DAVID STARR JORDAN
HIGH SCHOOL
STRUCTURAL STRENGTHENING
AND MODERNIZATION OF
AUDITORIUM AND BOILER HOUSE
2245 E. 103rd ST., LOS ANGELES, CAL.
STATE OF CALIFORNIA - DEPARTMENT OF GENERAL SERVICES
AS RE-DESIGNED FOR RECONSTRUCTION
25132 APPROVED NOV 20 1964

INDEX OF SHEETS, SCHEDULE AND MOSAIC PANEL DETAILS

DAVID STARR JORDAN
 HIGH SCHOOL
 STRUCTURAL STRENGTHENING
 AND MODERNIZATION OF
 AUDITORIUM AND BOILER HOUSE
 2265 E. 103RD ST., LOS ANGELES, CAL.
 STATE OF CALIFORNIA - DEPARTMENT OF GENERAL SERVICES
 DIVISION OF ARCHITECTURE AND CONSTRUCTION
 AS REVISED APR 13 1965
 25132 APPROVED NOV 20 1964
 APPLICATION NO. 100
 PER S. Morgan

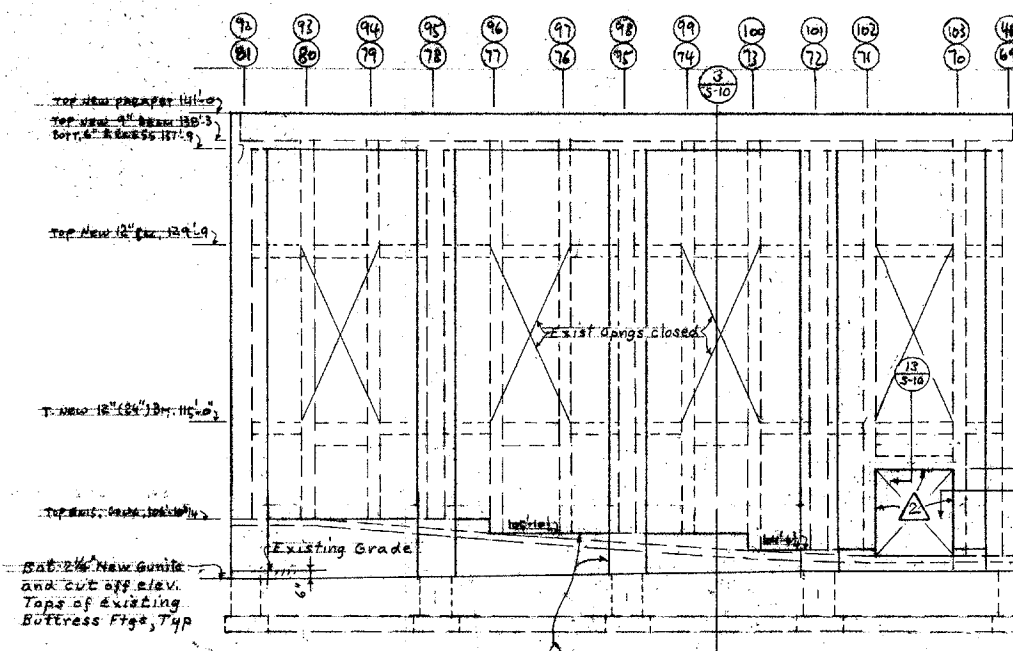
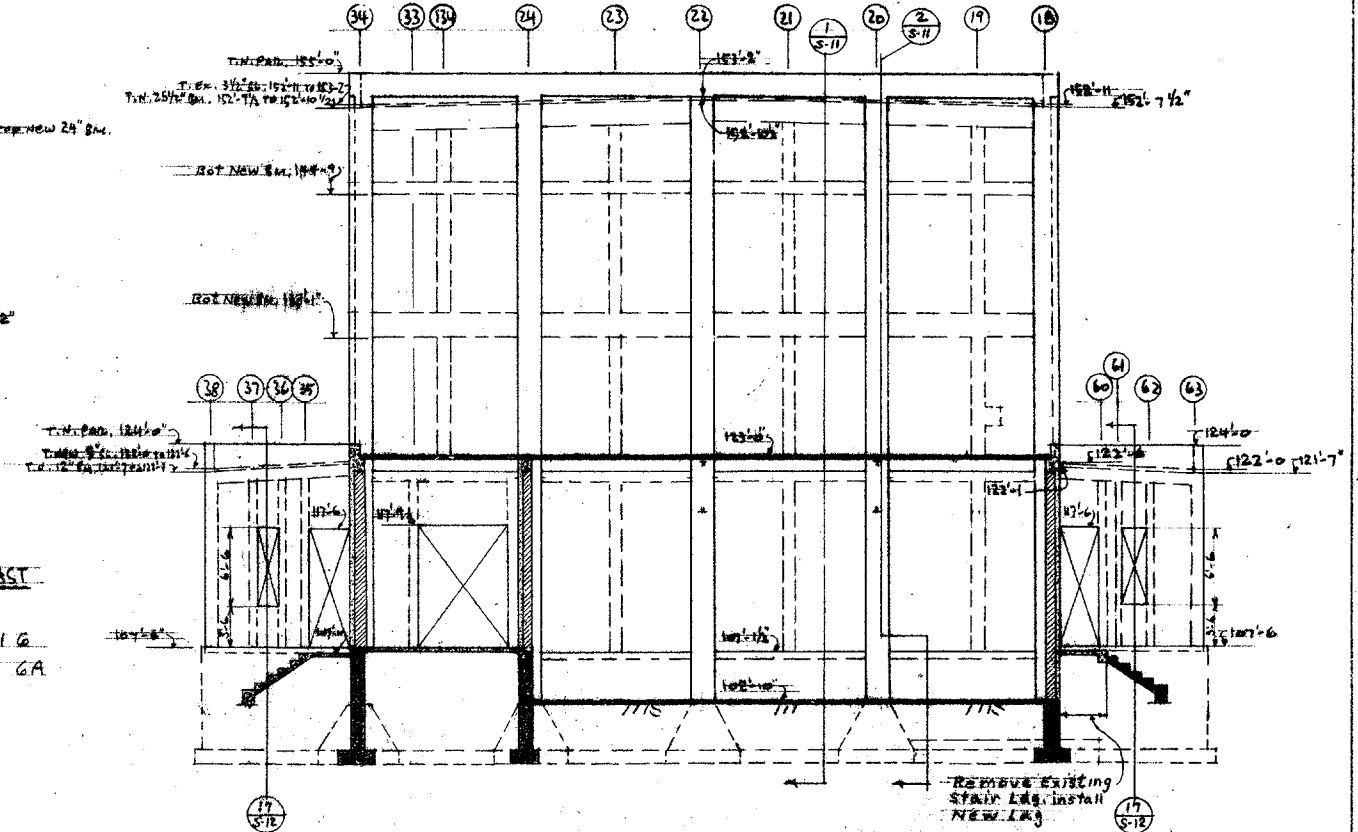
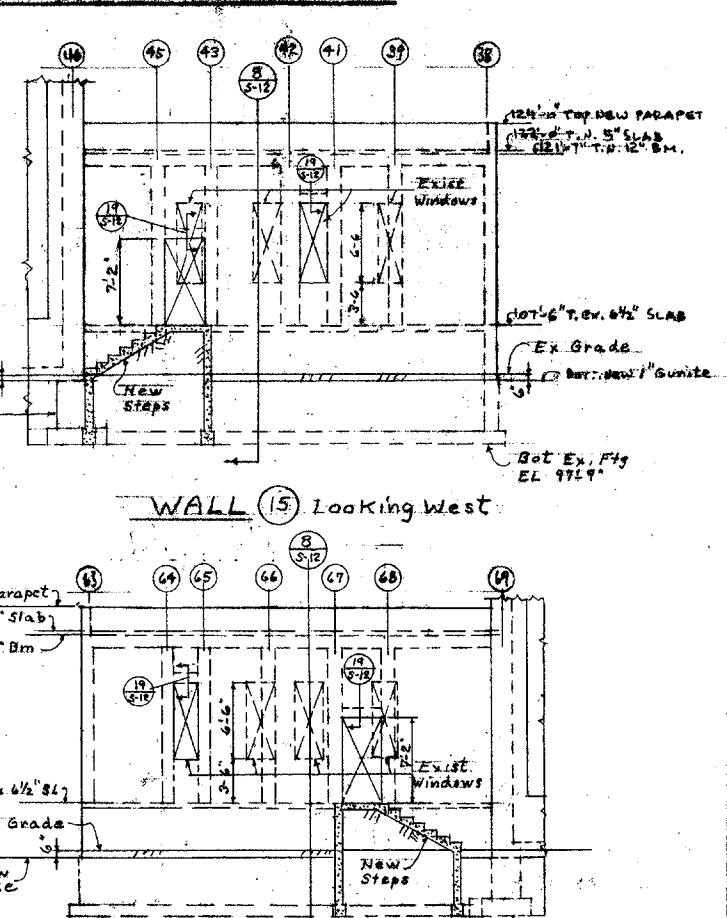
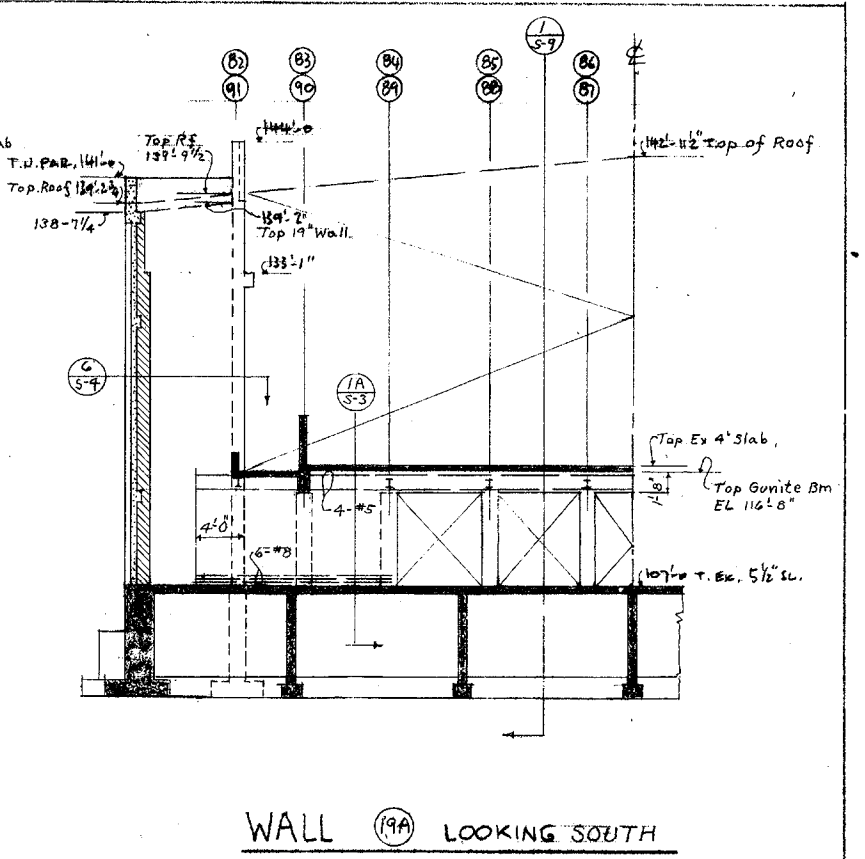
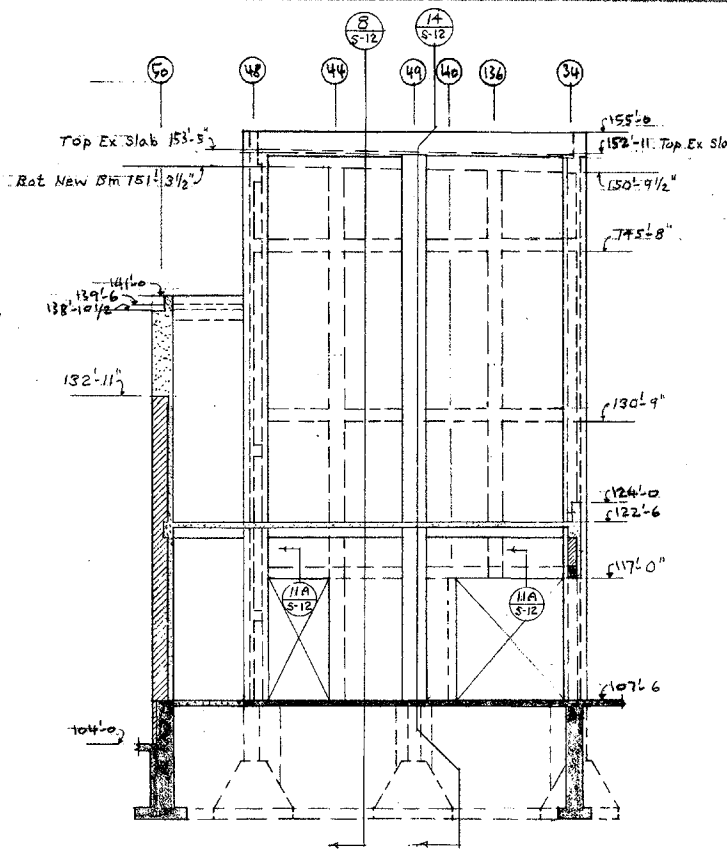
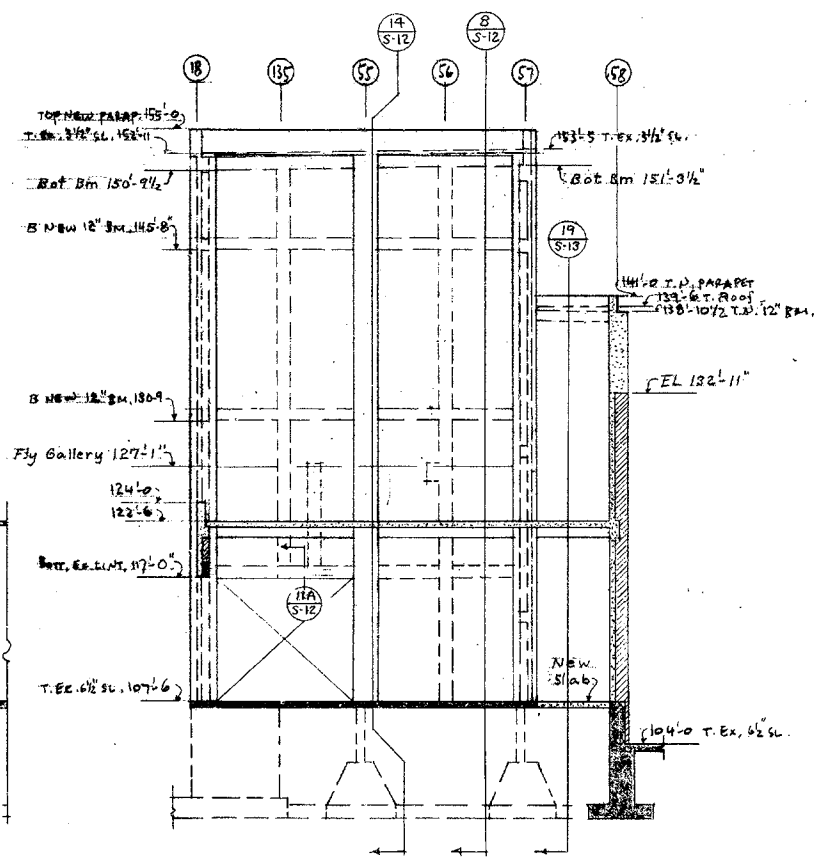
3 CHANGE ORDER T-507 Extend 10" conc wall to Elev 10'-0"

- 1 Extend 6" thick gunit to top of existing conc, eliminate ledge at EL 10'-0". Omit 2 1/4" thick gunit on face of existing conc, except at 3'-0" wide pilasters.
- 2 Omit Gunit projection at door jambs and head.

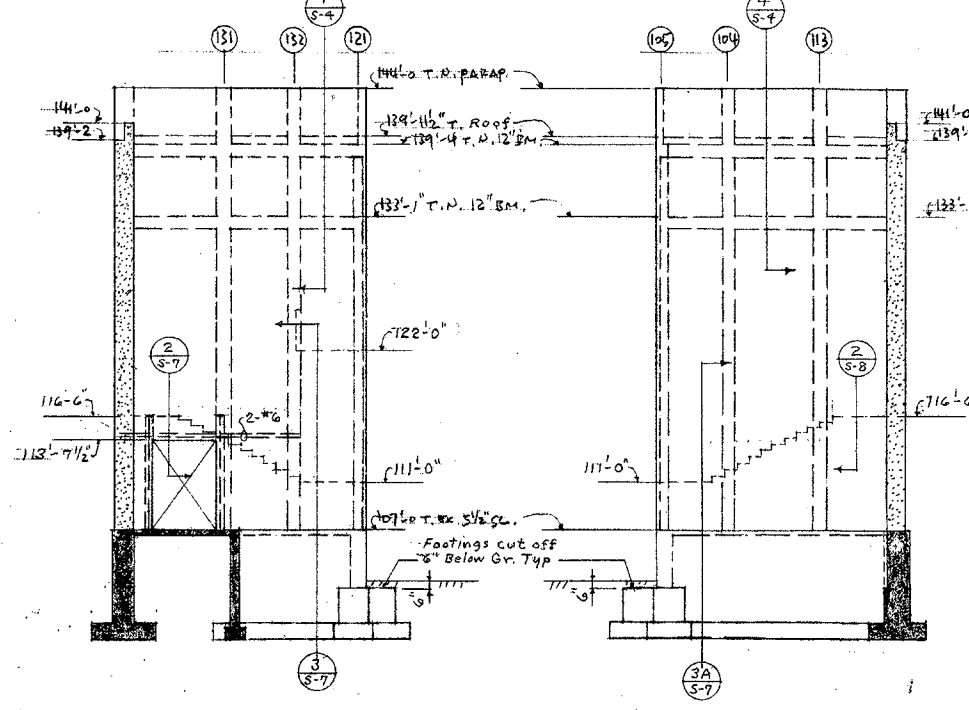
- ① Omit cut back of existing conc walls below the floor and omit 1" thick guniting on existing walls below floor
- ② See ① on sheet S-5

| DATE 11/20/64 DR LJD CH NBB SHEET S-8 | |

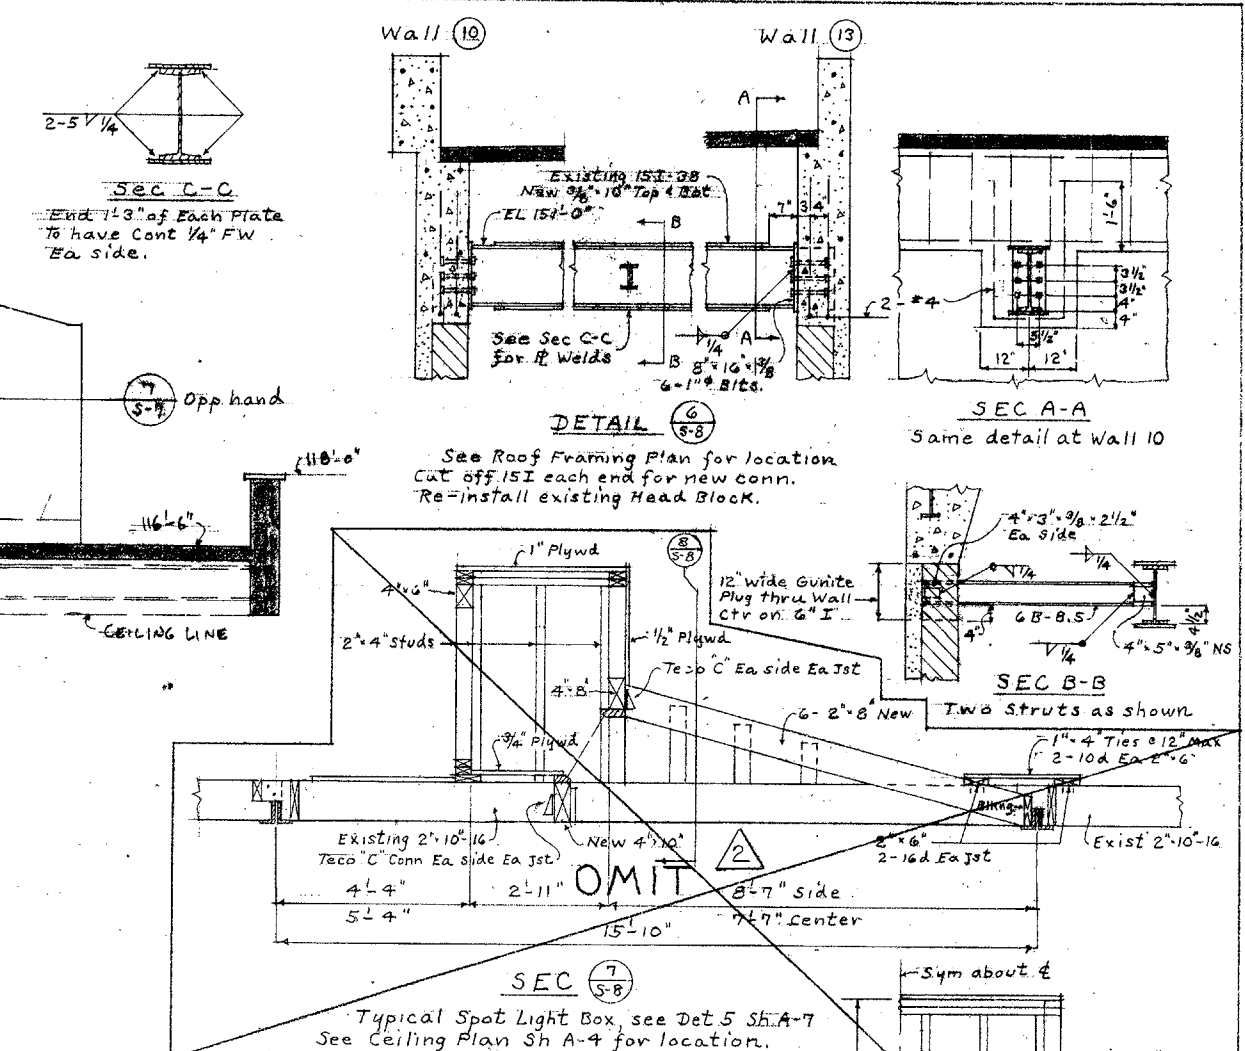
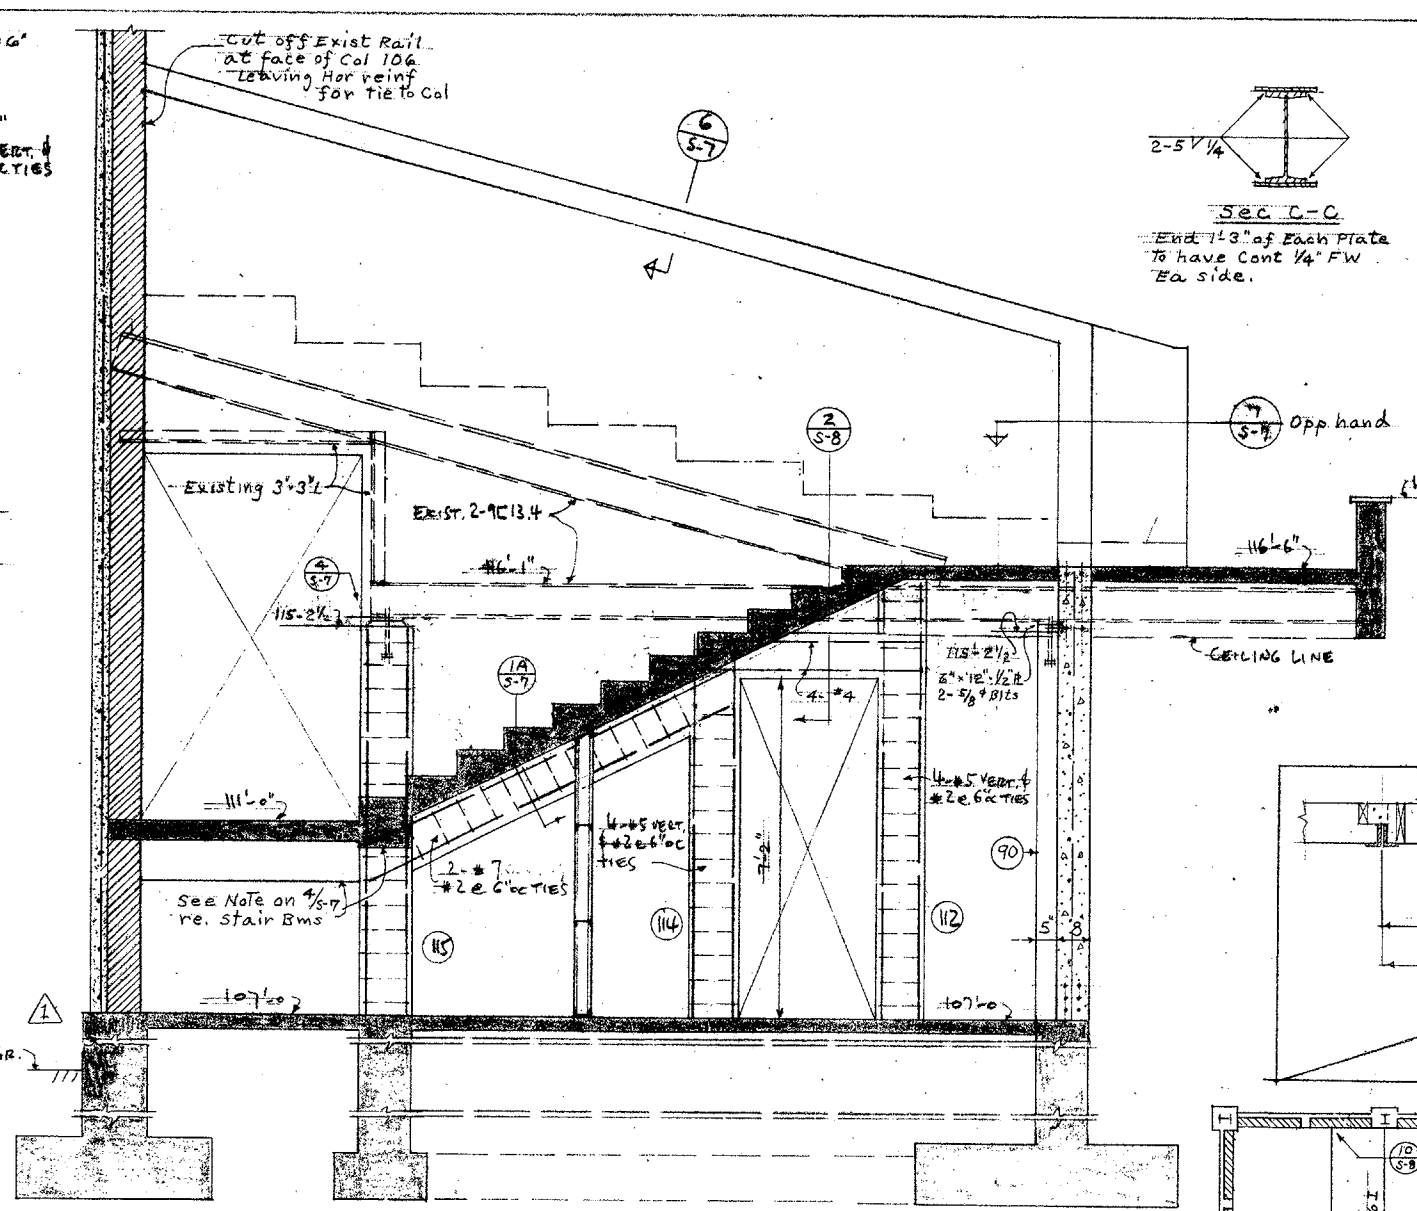
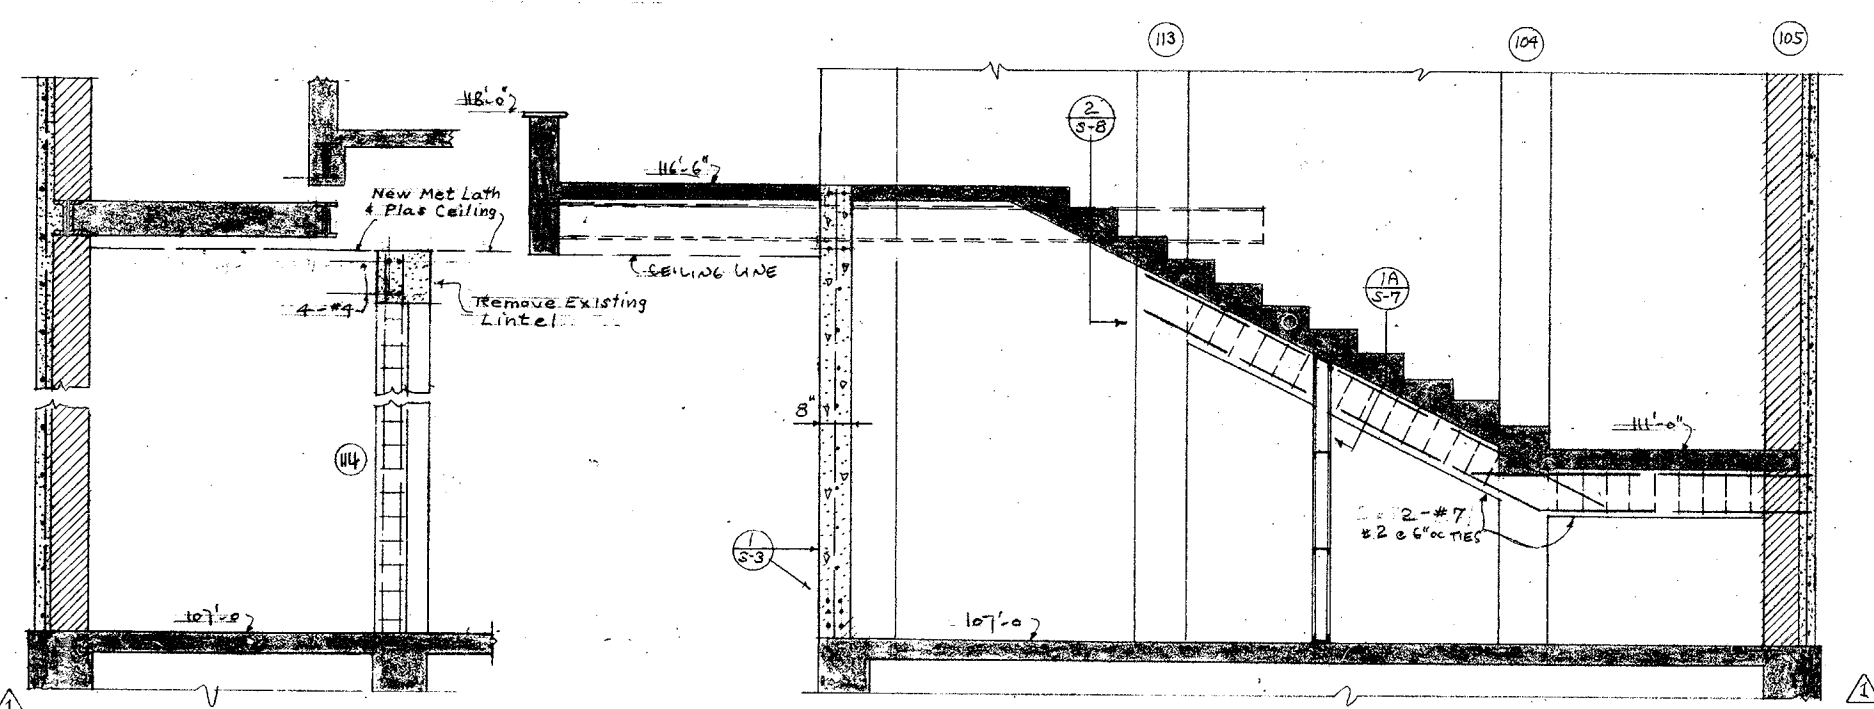
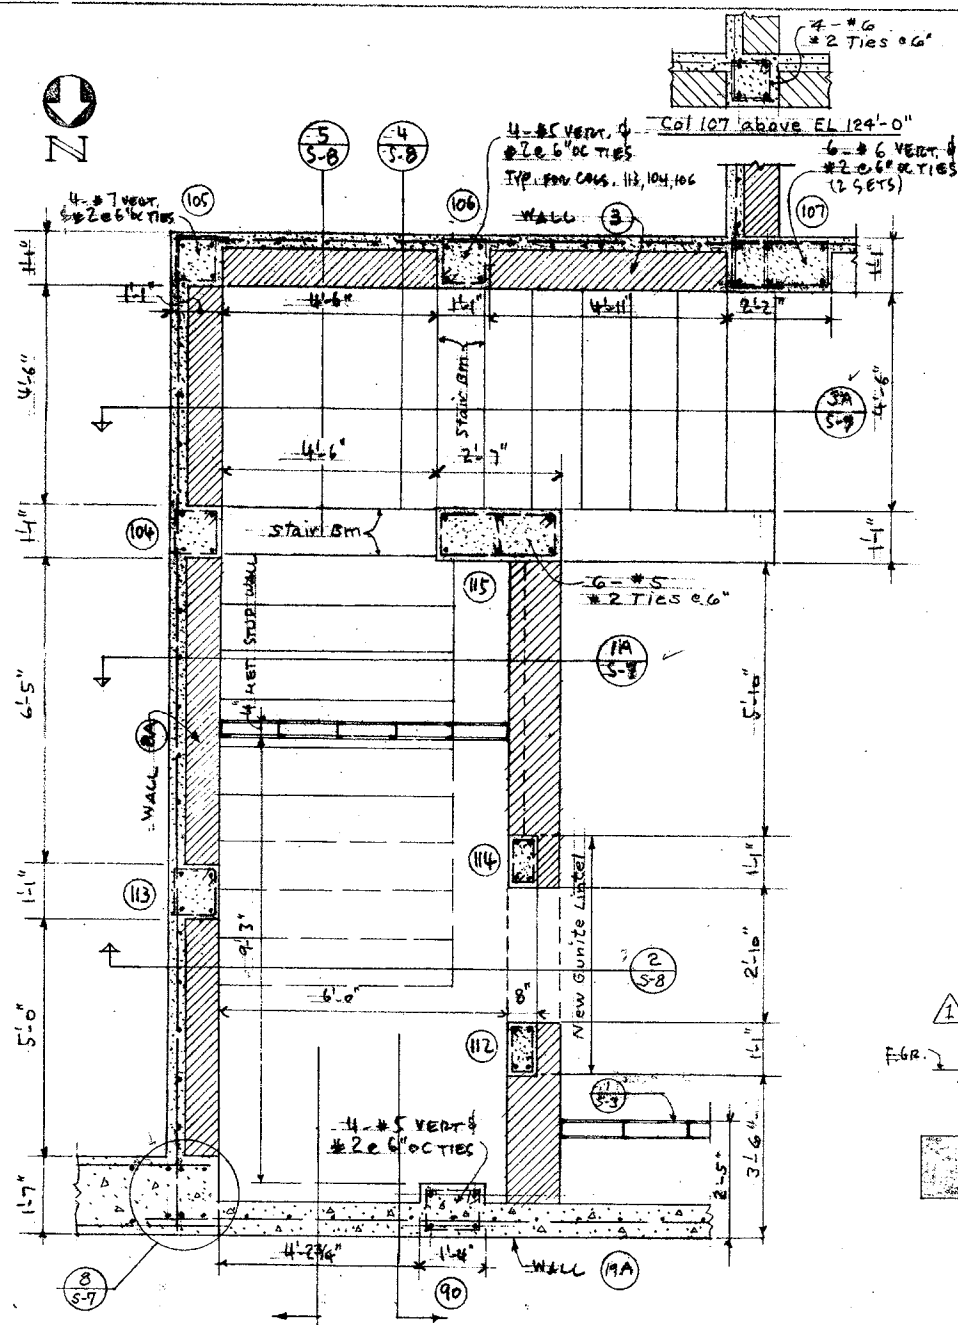
| 1 See 1 on sheet S-6 2 Omit new Spot Light box and new spot lights. Existing spot lights to remain. | |

SECTION 2 CHANGE ORDER T-517 Provide rigging to existing sheaves which shall be supported on existing head beams.
